**MOCK**  
**2026 ICC GROUP A AND B**  
**PUBLIC COMMENT HEARING**

2026 WABO ABM  
April 16, 2026

## **DISCUSSION GUIDE 2026 ICC CODE DEVELOPMENT CYCLE PUBLIC COMMENT AGENDA DISCUSSION GUIDE**

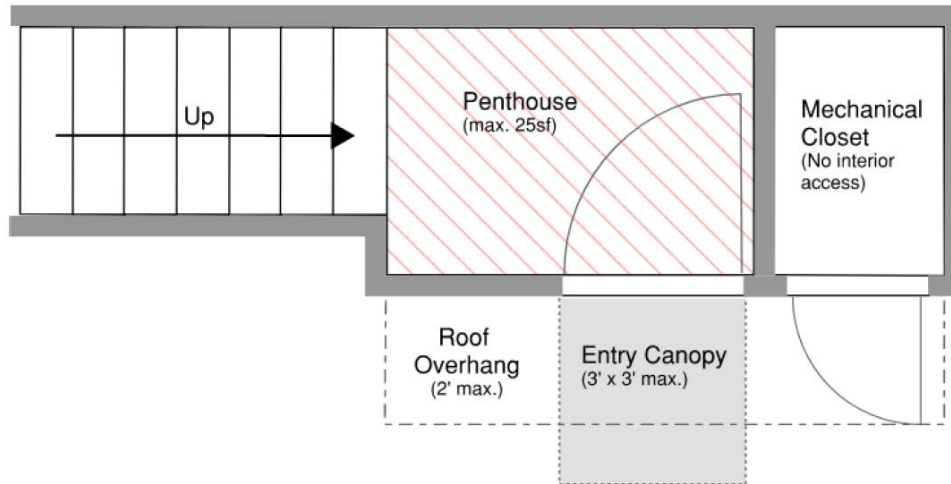
3. We have provided a more detailed requirement for the permitted elements or structures above the occupiable roof. Much of this language is taken from the City of Seattle policy regarding occupiable roofs in the IRC (See figure below).

See the following diagram showing the elements of a compliant penthouse:

(Alteration example from 2018 IEBC Commentary Figure 809.1)

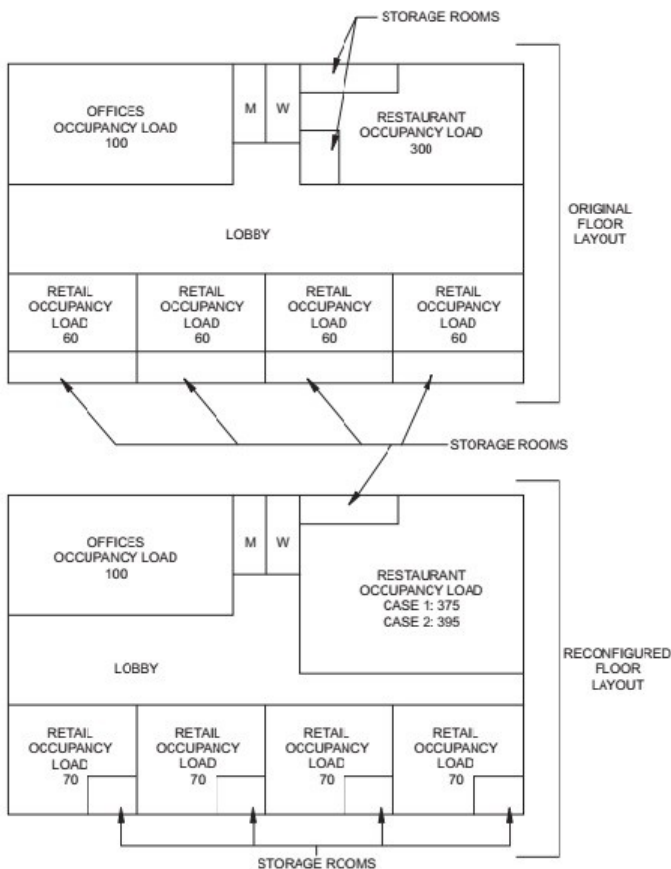
While we acknowledge that a significant occupant load increase could qualify as a change of occupancy, even within the same group classification (e.g., converting a restaurant to a bar/nightclub within Group A-2), we interpret the 20% allowance differently. We believe it should only apply to reconfigurations where the building's use or occupancy does not change, aligning with the definition of an alteration

(See Figure 809.1 as an example). This interpretation reflects that plumbing fixture requirements depend not only on occupant load but also on the building's use or occupancy type (see IBC Table 2902.1). For instance, in a change of occupancy scenario, converting a mercantile space (occupancy load factor = 60 sf/person) to a business use (occupancy load factor = 150 sf/person) could decrease the occupant load of the space but necessitate different plumbing fixture requirements. Applying the 20% exception in this scenario seems inappropriate because it could result in significantly insufficient plumbing fixtures for the new business use. Hence, this proposal is intended to correct this by removing the exception in Section 1009.1 and relocating it back to the alteration section.

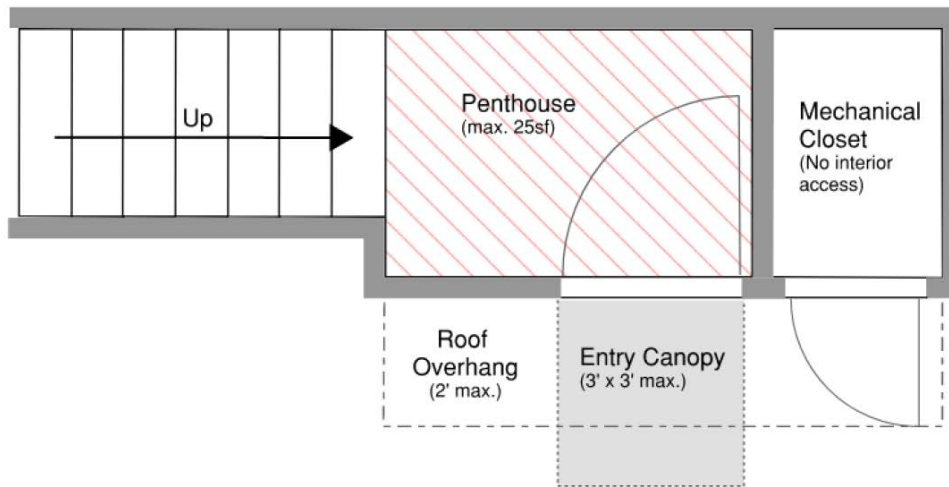
3. We have provided a more detailed requirement for the permitted elements or structures above the occupiable roof. Much of this language is taken from the City of Seattle policy regarding occupiable roofs in the IRC (See figure below).

See the following diagram showing the elements of a compliant penthouse:

(Alteration example from 2018 IEBC Commentary Figure 809.1)

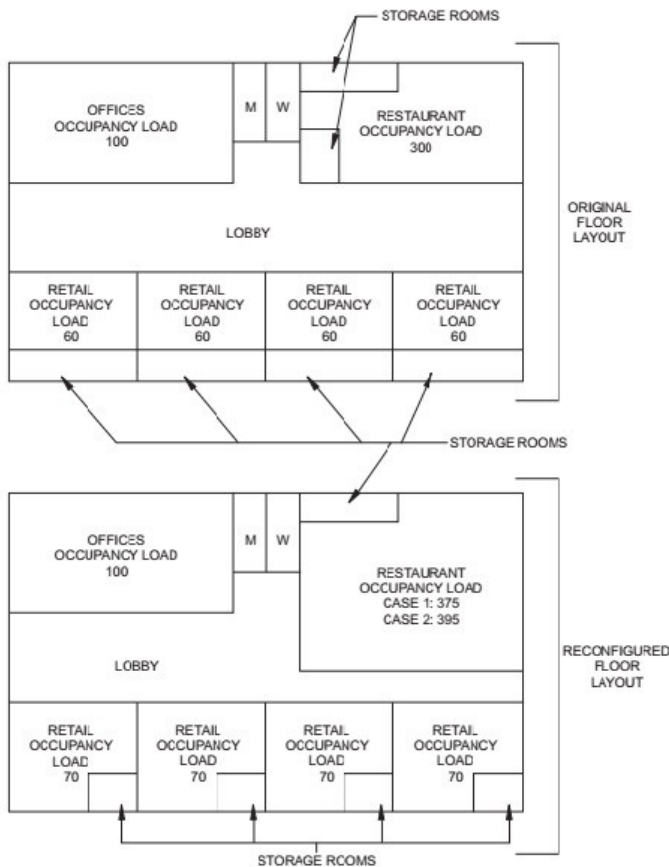
While we acknowledge that a significant occupant load increase could qualify as a change of occupancy, even within the same group classification (e.g., converting a restaurant to a bar/nightclub within Group A-2), we interpret the 20% allowance differently. We believe it should only apply to reconfigurations where the building's use or occupancy does not change, aligning with the definition of an alteration (See Figure 809.1 as an example). This interpretation reflects that plumbing fixture requirements depend not only on occupant load but also on the building's use or occupancy type (see IBC Table 2902.1). For instance, in a change of occupancy scenario, converting a mercantile

space (occupancy load factor = 60 sf/person) to a business use (occupancy load factor = 150 sf/person) could decrease the occupant load of the space but necessitate different plumbing fixture requirements. Applying the 20% exception in this scenario seems inappropriate because it could result in significantly insufficient plumbing fixtures for the new business use. Hence, this proposal is intended to correct this by removing the exception in Section 1009.1 and relocating it back to the alteration section.
